Basement Wall Side View

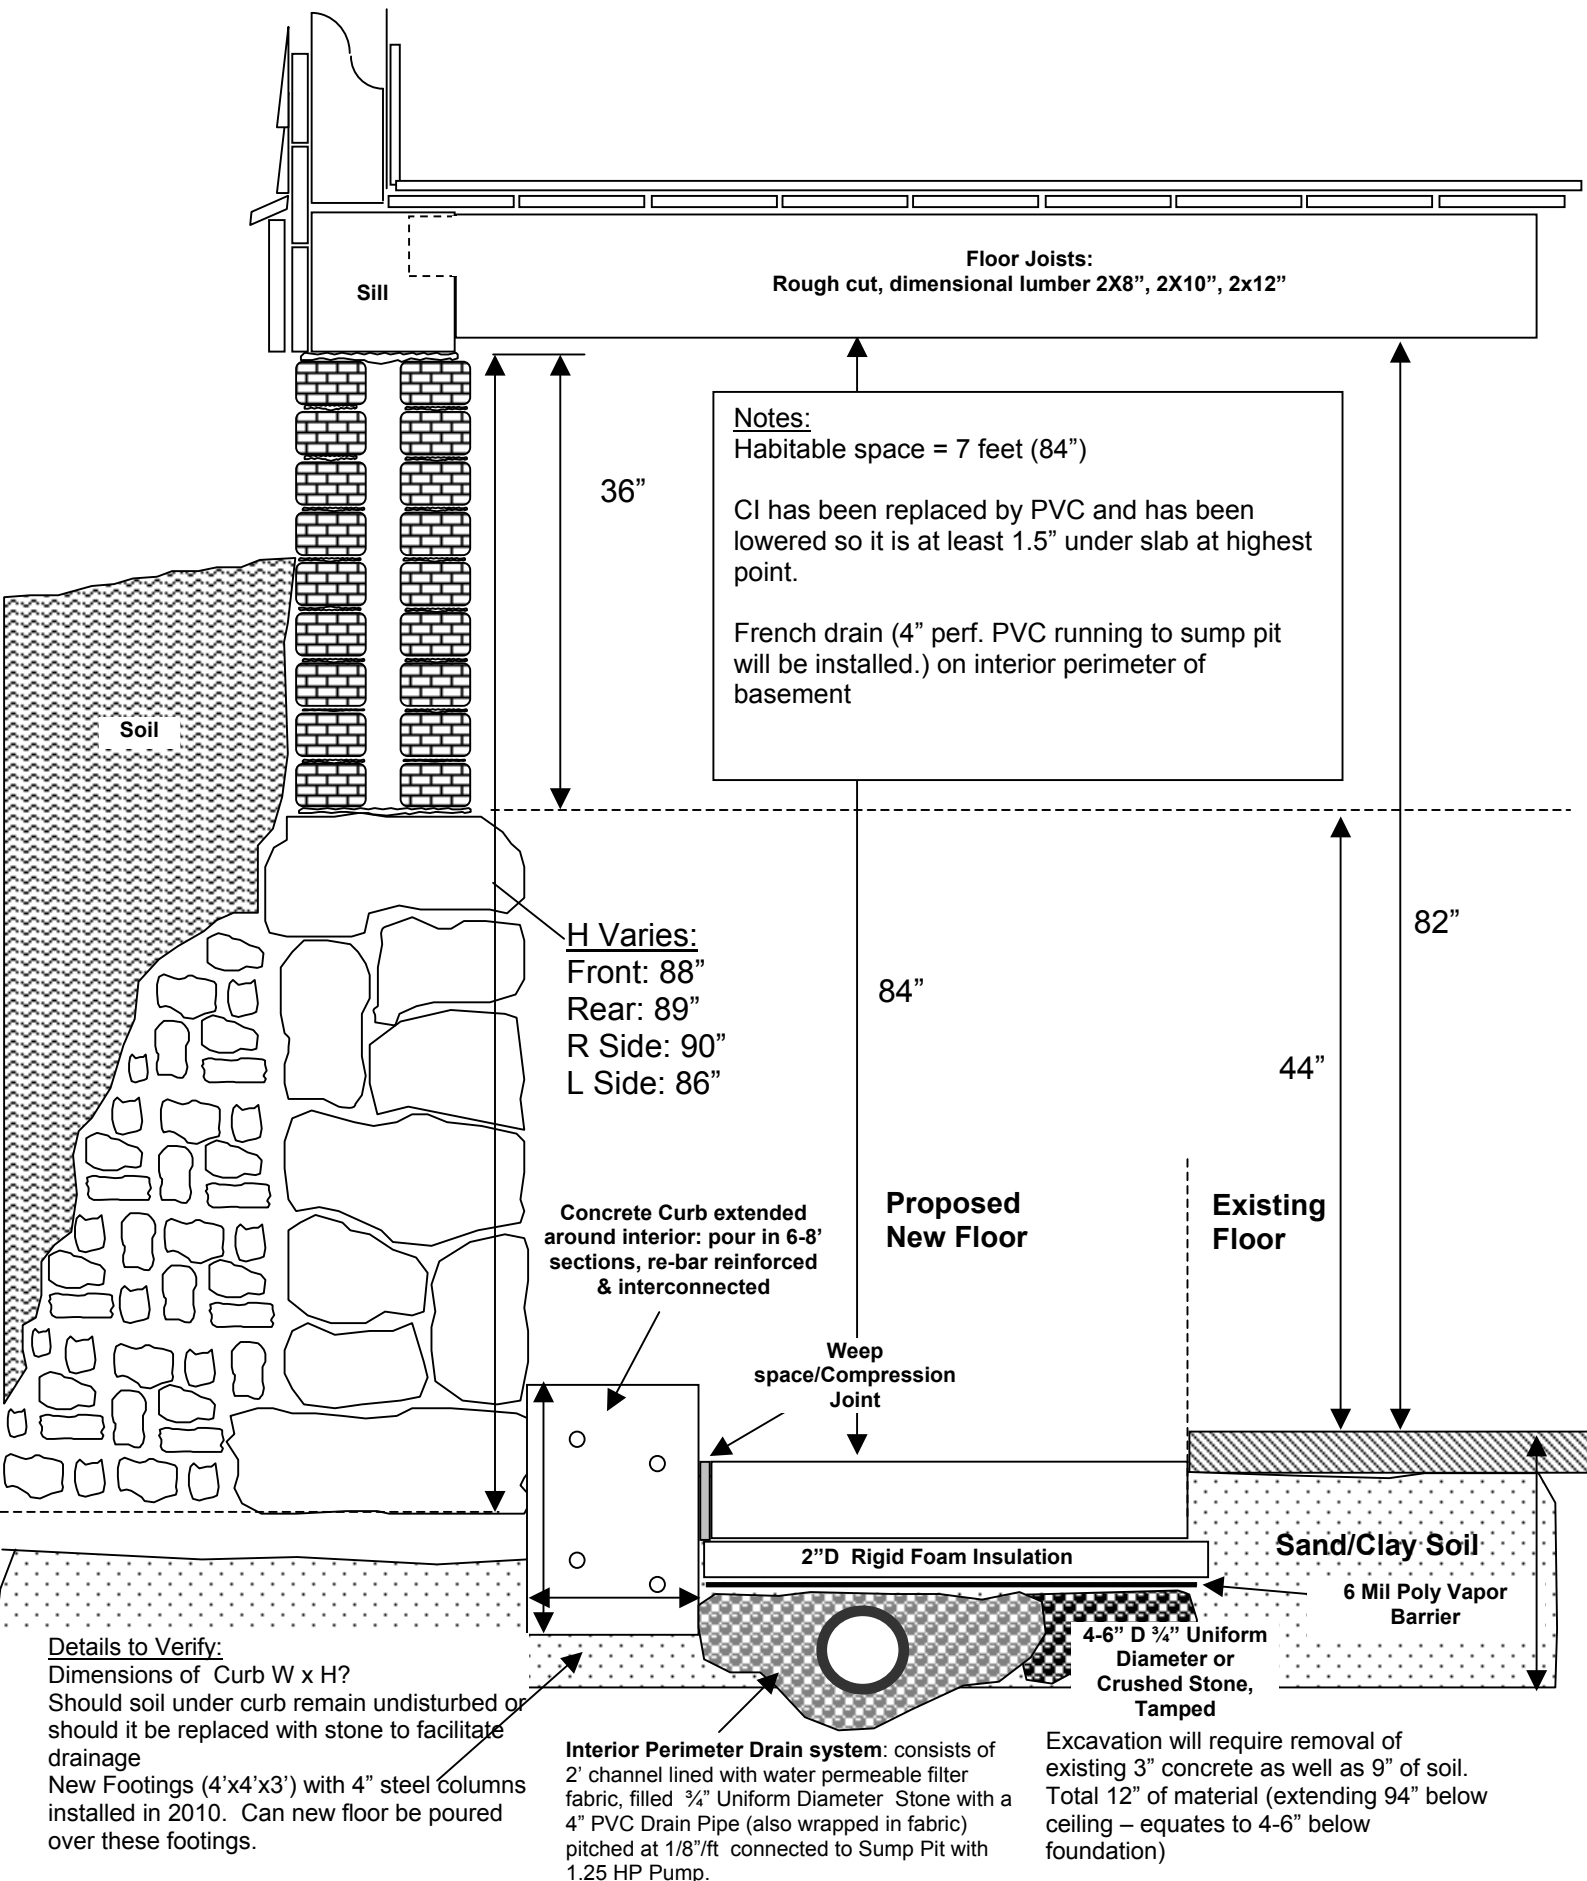
Details to Verify:
Dimensions of Curb W x H?
Should soil under curb remain undisturbed or should it be replaced with stone to facilitate drainage
New Footings (4'x4'x3') with 4" steel columns installed in 2010. Can new floor be poured over these footings.
